HUGHES SERVICE INFORMATION NOTICE

NOTICE NO. N-115.1*

SUBJECT: REWORK - ENGINE MOUNTING HANGER ASSEMBLIES 269A8617
AND 269A8618 TO ELIMINATE POSSIBLE ENGINE
CRANKCASE TO HANGER ASSEMBLY INTERFERENCE

MODELS AFFECTED: All 269A, 269A-1, 269A (TH-55A) and 269B Helicopters
269C Helicopter Serial No. 0001 thru 0264

Figure 1. Engine Mounting Hanger Rework (sheet 2 of 2)

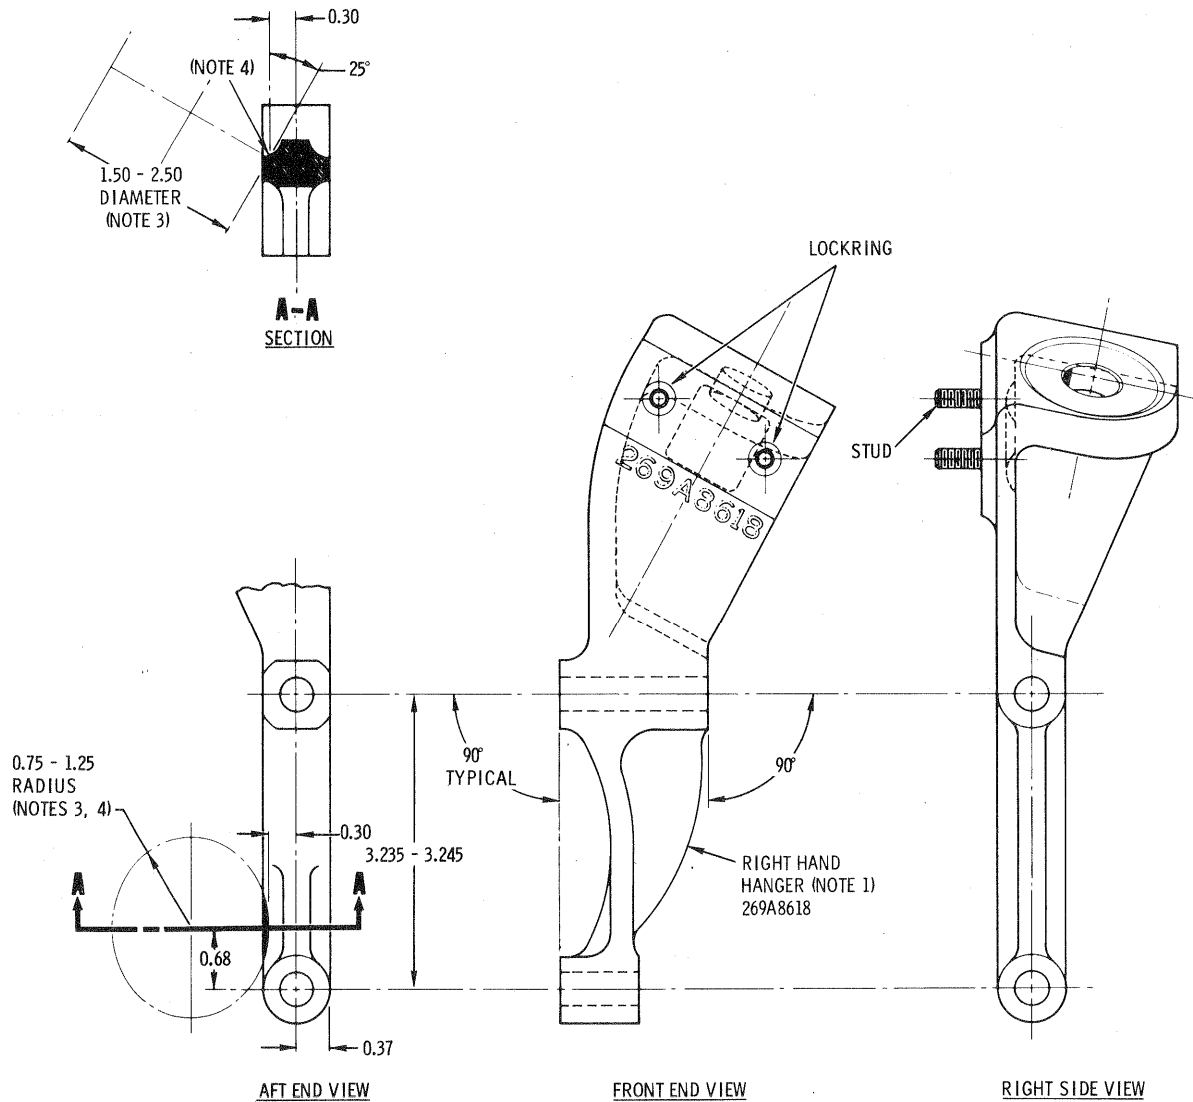
PREFACE: Interference between subject hanger assemblies and the crankcase of the
engine may occur, due to dimension change on current engine crankcase
castings. Interference does not occur with current production hanger
assemblies which conform with dimensions specified in this Notice.

2. Remove material and finish reworked area of left hand and/or right hand hanger as shown in Figure 1.
 3. Install reworked hanger assembly on engine in reverse order of removal; perform additional reassembly as required.
 4. Torque two lateral hanger mounting bolts to 300 - 350 inch-pounds.
- c. Record rework of left hand and/or right hand hanger assembly in Component Record of Helicopter Log Book.

Figure 1. Engine Mounting Hanger Rework (sheet 1 of 2)

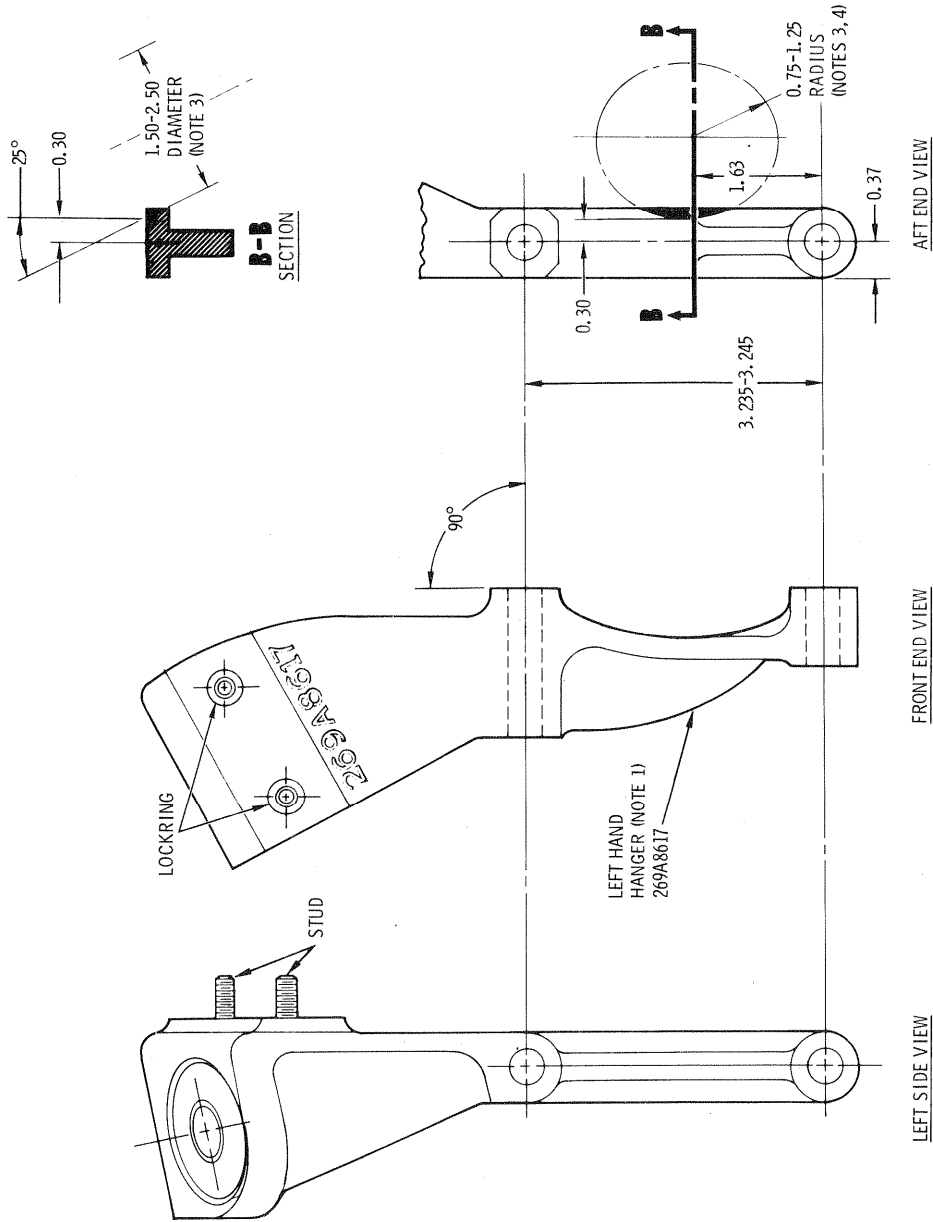
1. ALL DIMENSIONS IN INCHES.
2. MATERIAL IS CAST MAGNESIUM, AZ91C COMPOSITION, T6 TEMPER (QQ-M-56 OR QQ-M-55).
3. RADIUS AS REQUIRED FOR DIAMETER WITHIN LIMITS SPECIFIED FOR MATERIAL REMOVAL TO DIMENSIONS INDICATED.
4. SURFACE TO BE FINISHED TO 125 MICRO-INCHES RHR (ROUGHNESS HEIGHT RATING).
5. ACCOMPLISH EXTERIOR SURFACE TREATMENT OF MACHINED AREA (DOW NO. 19-MIL-M-3171, TYPE VI OR DOW NO. 1-MIL-M-3171, TYPE I), INCLUDING PAINT TOUCH-UP (SECTION 2, BASIC HMI).
